# UNITED STATES PATENT AND TRADEMARK OFFICE

APPLICATION NO.	FILING DATE	FIRST NAMED INVENTOR	ATTORNEY DOCKET NO.	CONFIRMATION NO.
10/702,104	11/04/2003	Gregory B. Altshuler	105090-0129	6794

**Office Action Summary**

### **DETAILED ACTION**

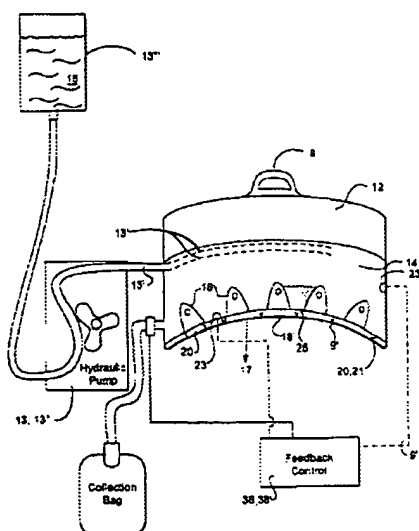
Claims 1, 2, 4-7, 13, 19 and 20 are rejected under 35 U.S.C. 102(b) as being anticipated by U.S. Patent 5,300,097 to Lerner et al. Lerner et

al. teach a handheld device for treating a skin condition with optical fiber protuberances for contacting the skin and an optical source (Fig. 2, # 40) positioned to provide radiation via the fiber optics. The optical fibers are interpreted as forming a brush. The fibers are capable of providing force to the skin.

Regarding claims 19-20, the source is within the handheld unit (Fig. 2).

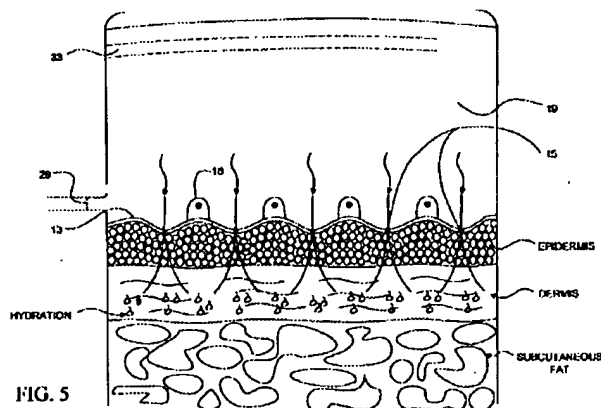
Claims 1, 22 and 23 are rejected under 35 U.S.C. 102(e) as being anticipated by U.S. Patent 6,350,276 to Knowlton. Knowlton discloses an apparatus for treating tissue using energy sources that may be light (Col. 7, lines 55-56). Figure 5 (herein), from a cross-referenced

(and  
incorporated)  
Knowlton  
patent

(6,425,912), teaches energy sources (Fig. 5, # 18) that conform to the skin, the irregular surface forming

protuberances. Knowlton teaches cooling of the sources and tissue using a liquid ( Fig. 2B, # 15) that can be in a liquid or gaseous state, or may exist in two or more phases and may undergo a phase change as part of its cooling function (Col. 5, lines 29-35), such as melting or evaporation (whereby heat is absorbed by the fluid as a latent heat of fusion or evaporation).
